Board of City Commissioners

3. **Consider the request from the Bismarck Airport for approval of Weisz and Sons Wetland Phase 5 Completion Contract Change Order No. 5 and Request to Wave Change Order Policy.**

Change Order No. 5
Date June 3, 2024

Airport Name	Bismarck Airport	Change Order No.	5
Location	Bismarck, ND	Section	3
AIP Project #	3-38-0003-0062-2020, 3-38-0003-0064-2020	KLJ Project #	1805-02200.3
Contractor	Weisz & Sons, Inc.	Owner's Project #	APG.AIP62.CONST, APG.AIP64.CONST

SHEET
G-1R.2

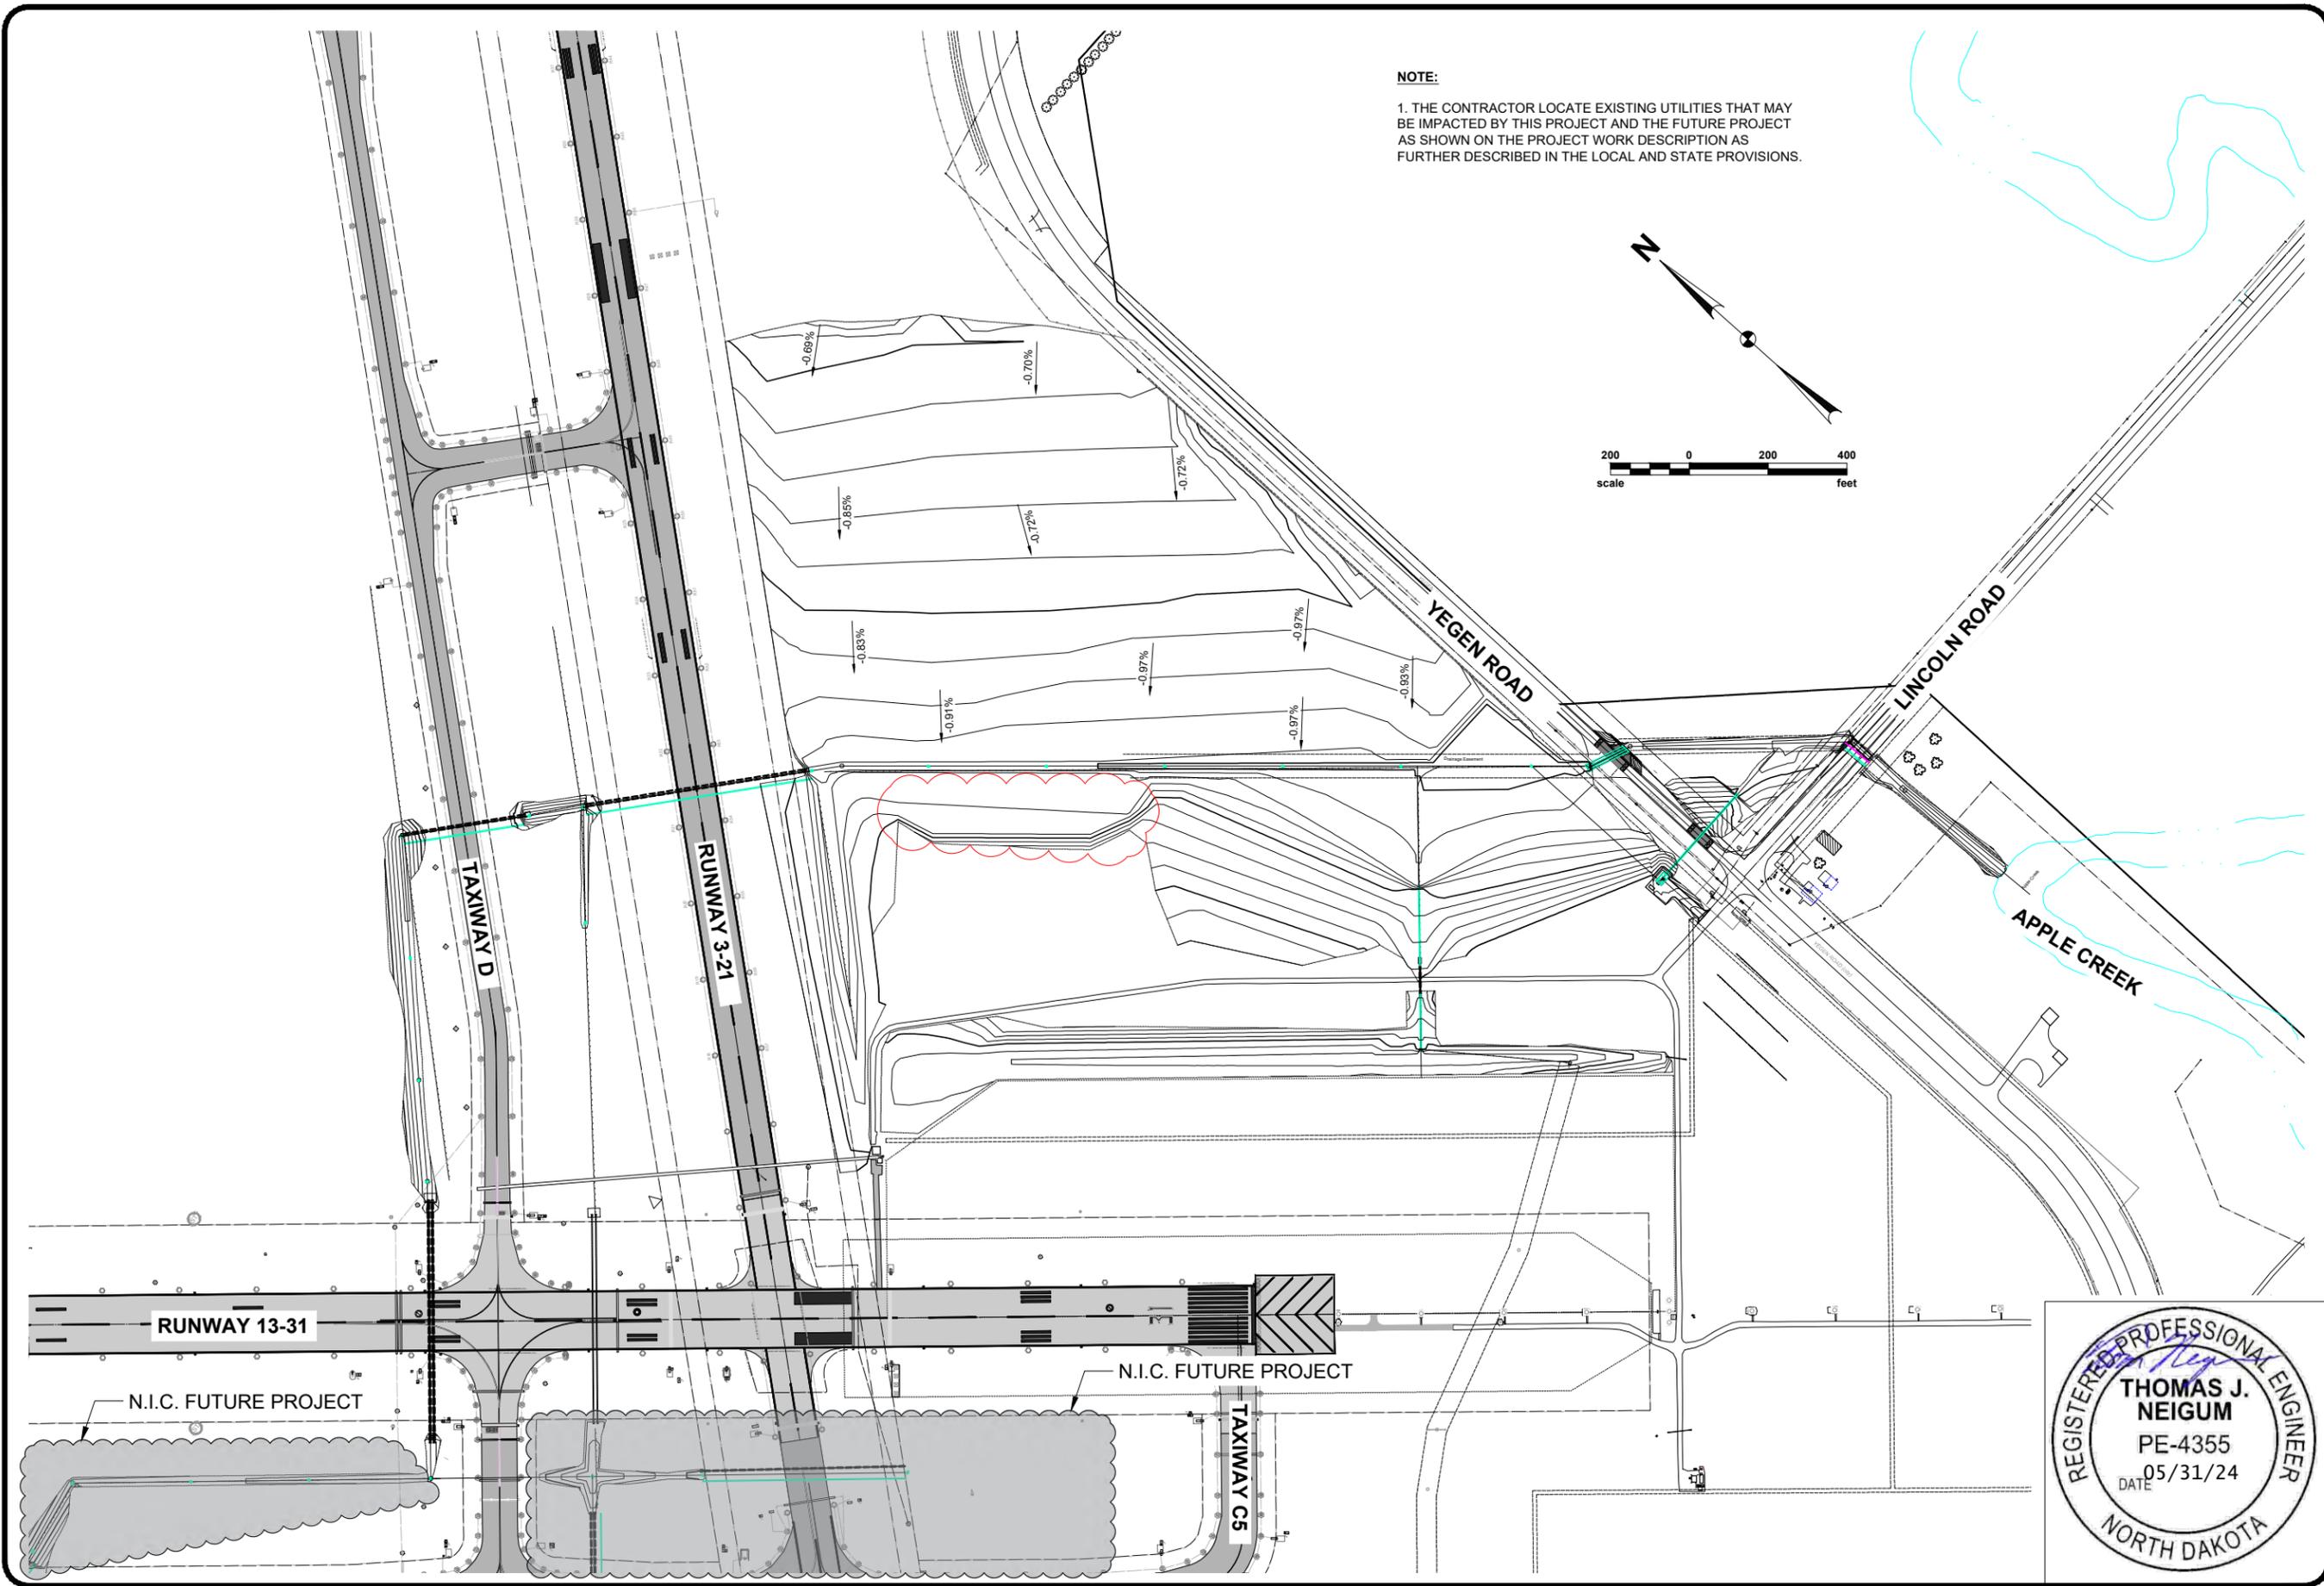
The cost shall include all costs including but not limited to removing and replacing topsoil; mulching; seeding; providing the Engineer with survey after the topsoil is stripped from the excavation area and before the excavated material is removed; providing the Engineer with survey before the topsoil is replaced on the excavation area and a stamped drawing showing the excavation area quantity for the Owner's original contract; survey of the topsoil stockpile quantity removed from the excavation area and providing the Engineer with the survey and stamped drawing showing the topsoil quantity for the Owner's original contract, removing excavation and placing it in the embankment area shown by the Contractor including moisture conditioning and compaction of the embankment material once placed in the embankment area as specified in Specification P-152.

Replace plan sheets 15R, G-1R, G-3R with the attached revised plan sheets 15R.2, G-1R.2, G-3R.2.

SHEET TITLE: TOPSOIL SEED AND MULCH EXHIBIT

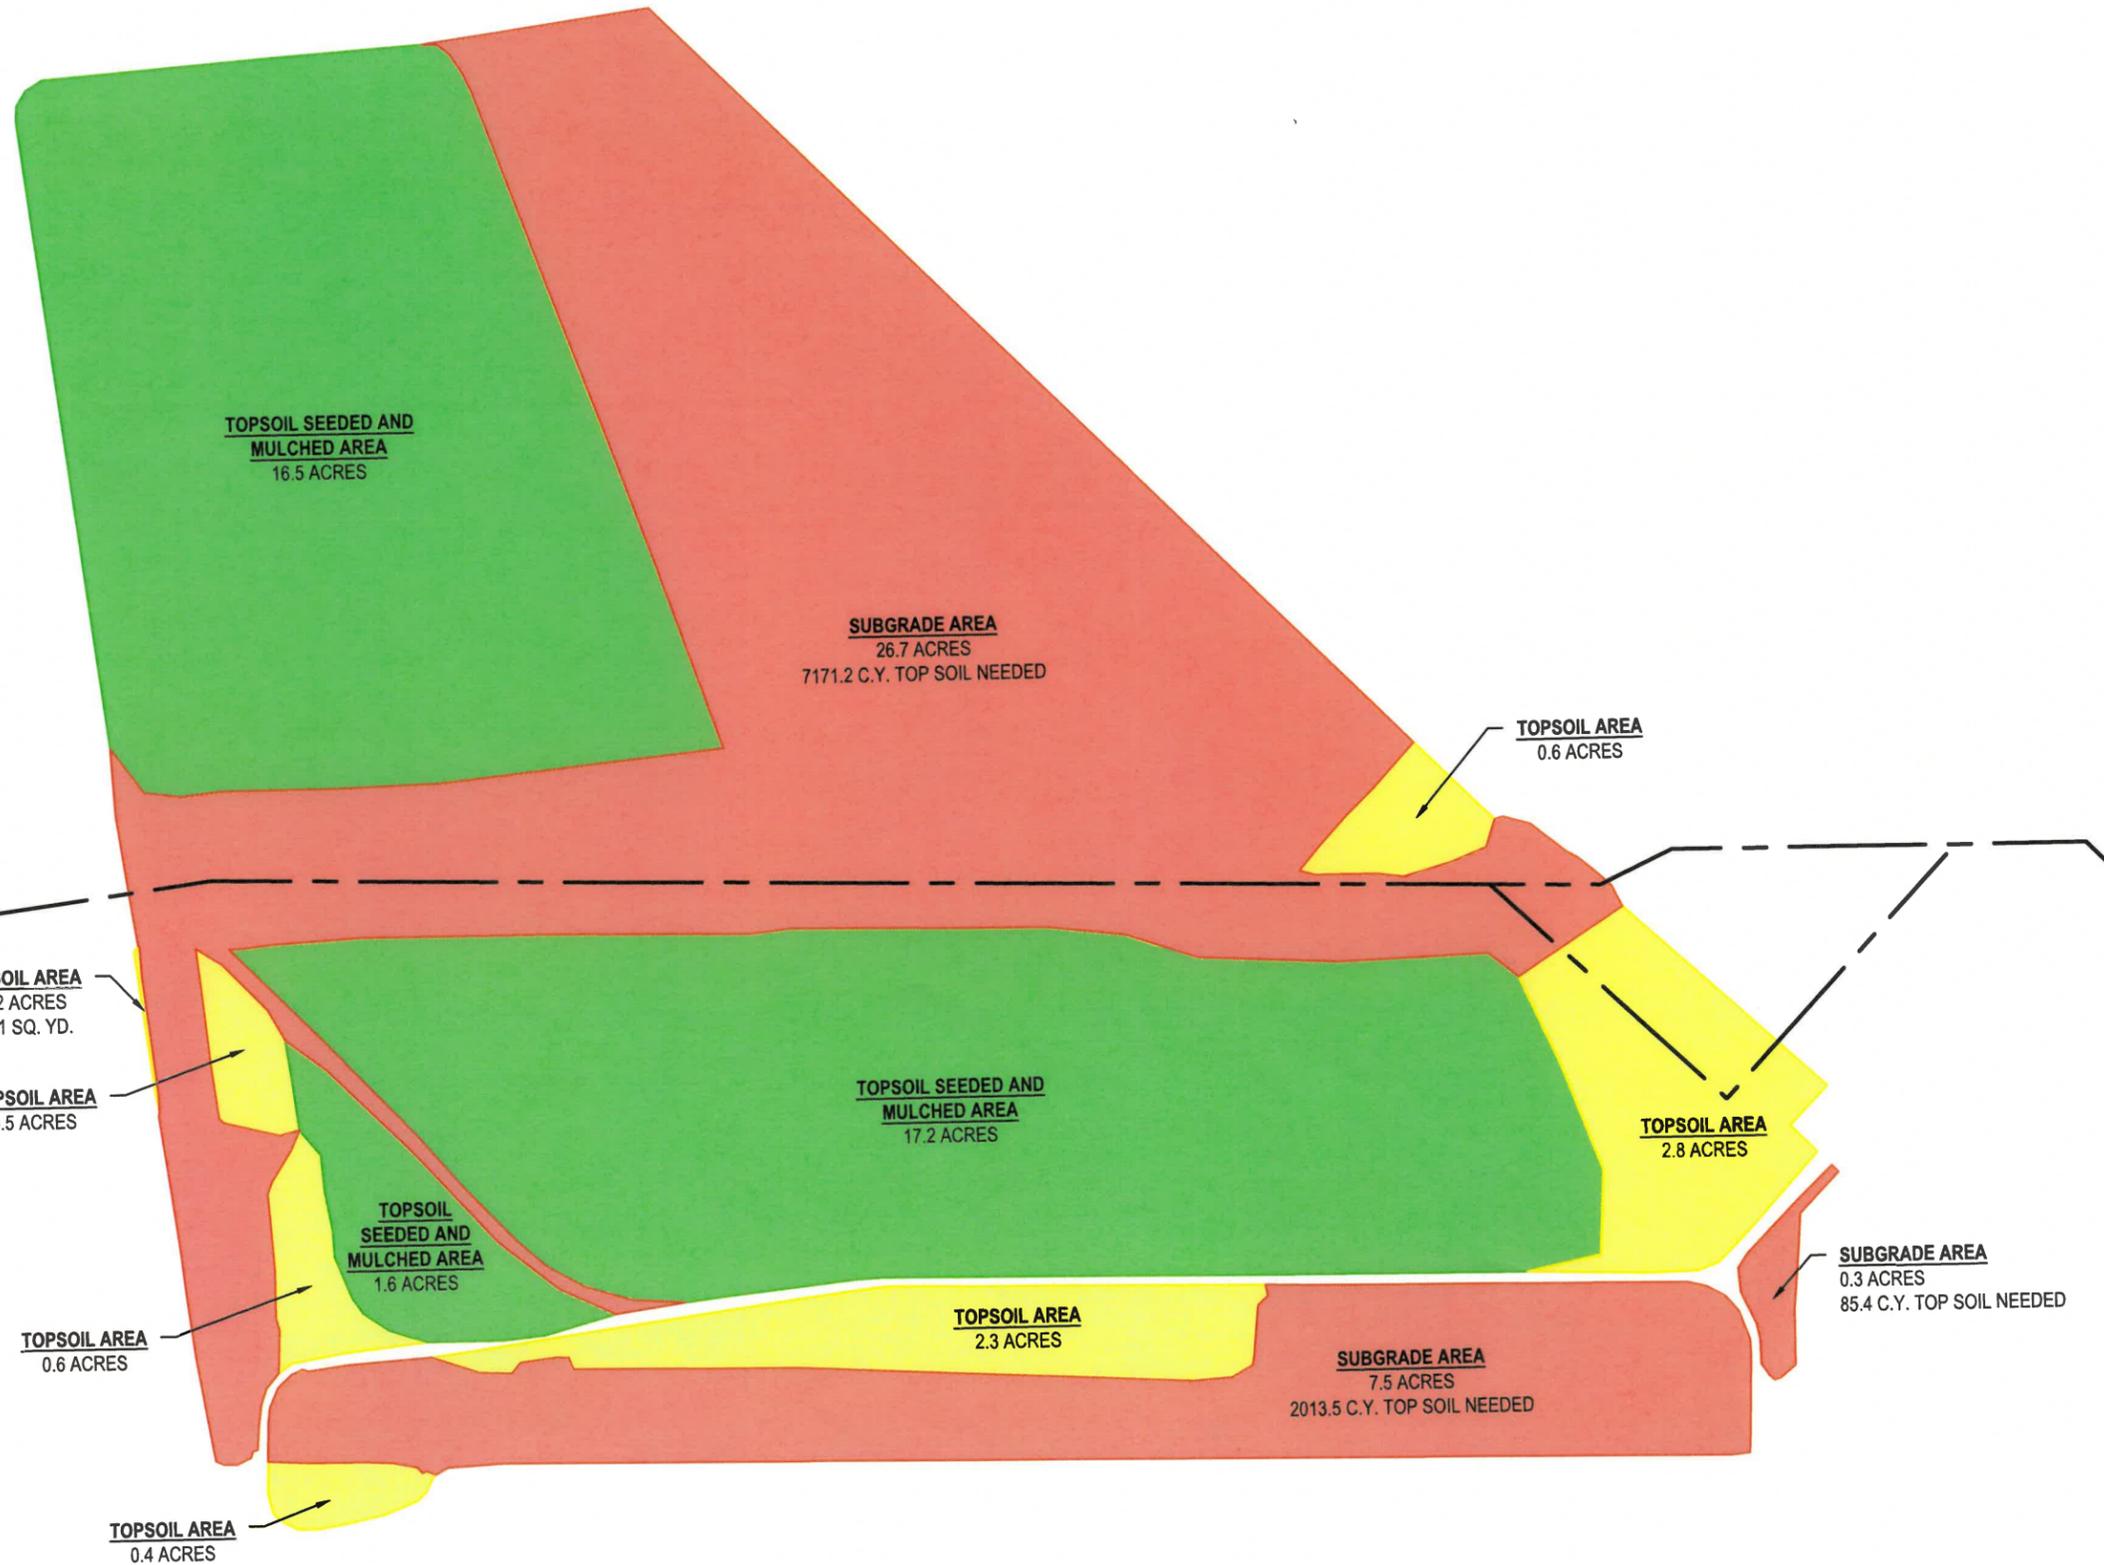
We have had our subcontractor (Midwest Erosion Control) complete seeding and mulching on the areas that we had final verification on subgrade and topsoil. Mountain Plains has surveyed the area that was seeded and mulched and the total area is 35.3 acres. (See attached Mountain Plains Exhibit) The completion contract – Item 19, Topsoil, Seed, Mulch included 50 acres and states that any additional area will require a change order. Mountain Plains has surveyed the areas that were disturbed by KLE and will need to be seeded and mulched, this amount comes to an additional 49.7 acres. This adds up to a total of 85 acres (35.3 + 49.7) on the project to seed and mulch. We request a change order for the additional 35 acres (85 – 50).

SHEET TITLE: TOPSOIL SEED AND MULCH EXHIBIT

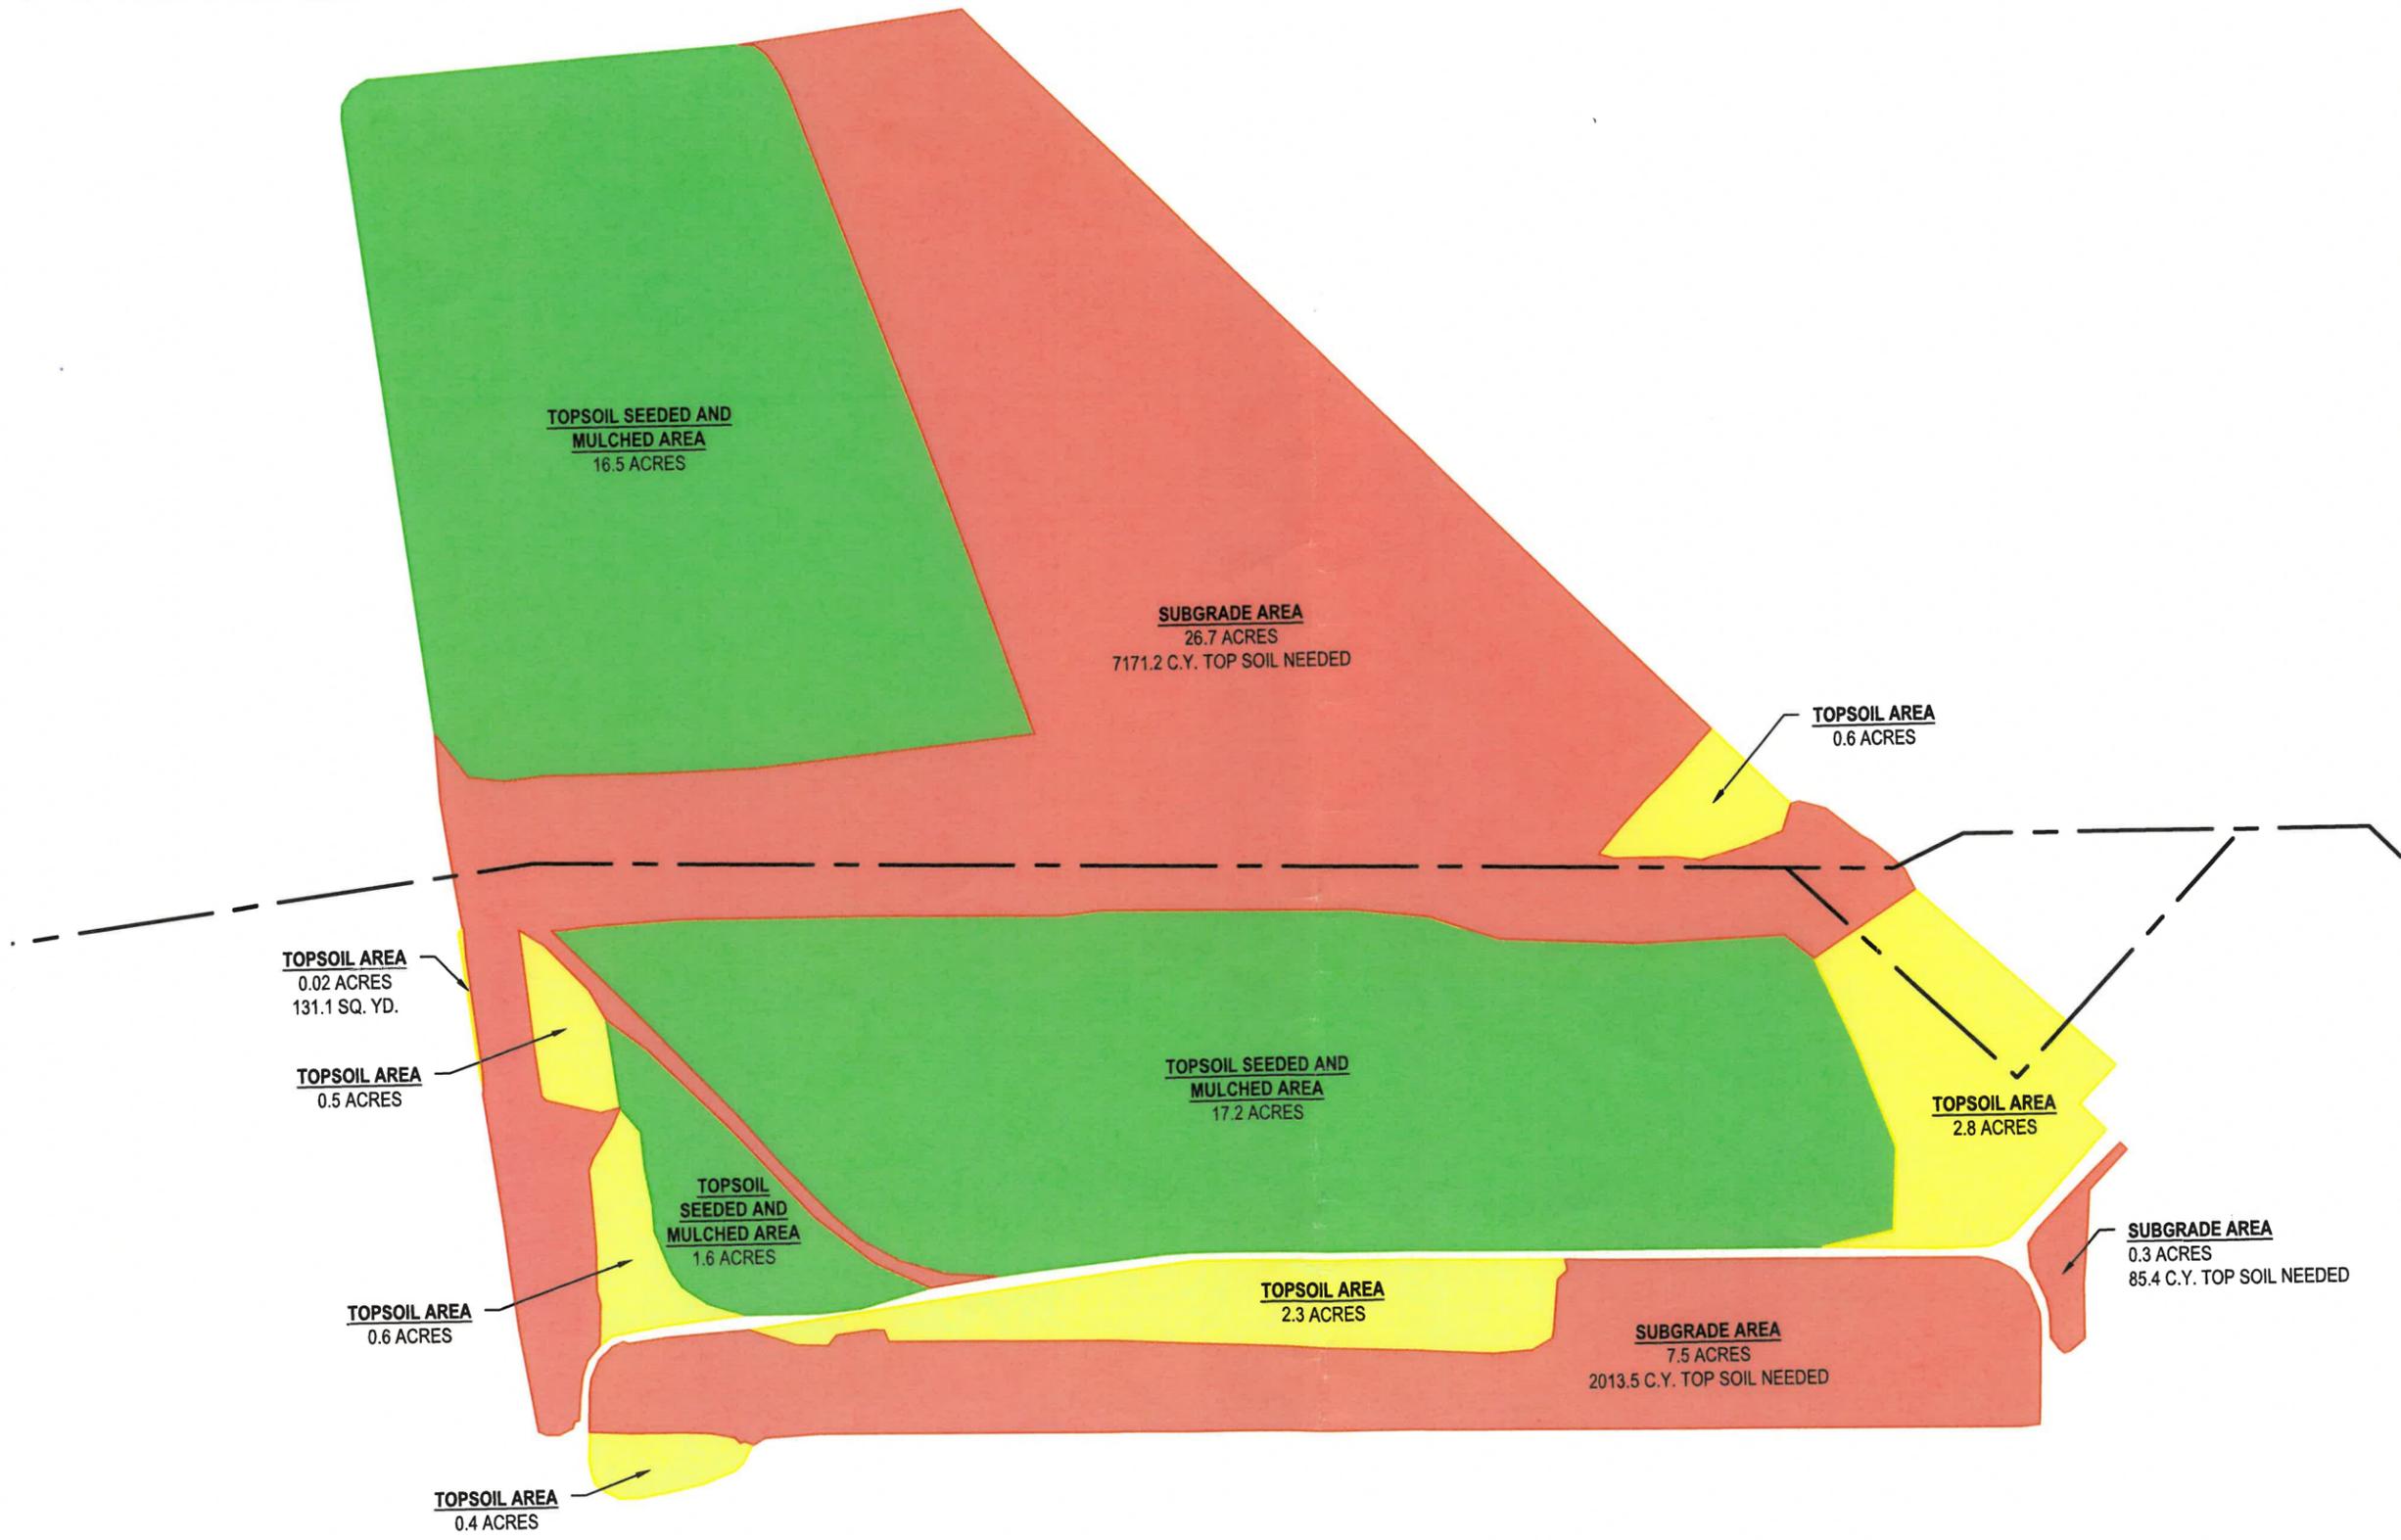
- 1) Northern Improvement – Frontier Precision Pile 1,500 CY @ \$20.00/CY = \$30,000.00
- 2) Northern Improvement – Asphalt Plant Pile 5,100 Tons @ \$22.00/Ton = \$112,200.00
- 3) Weisz & Sons - NE Bismarck Pile 8,100 Tons @ \$27.00/Ton = \$218,700.00

1. QUANTITIES AND CALCULATIONS ARE APPROXIMATE.
2. TOTAL DISTURBED AREA = 77.0 ACRES
3. TOTAL TOPSOIL NEEDED = 9270.1 C.Y.
4. TOTAL SEED AND MULCH NEEDED = 41.8 ACRES
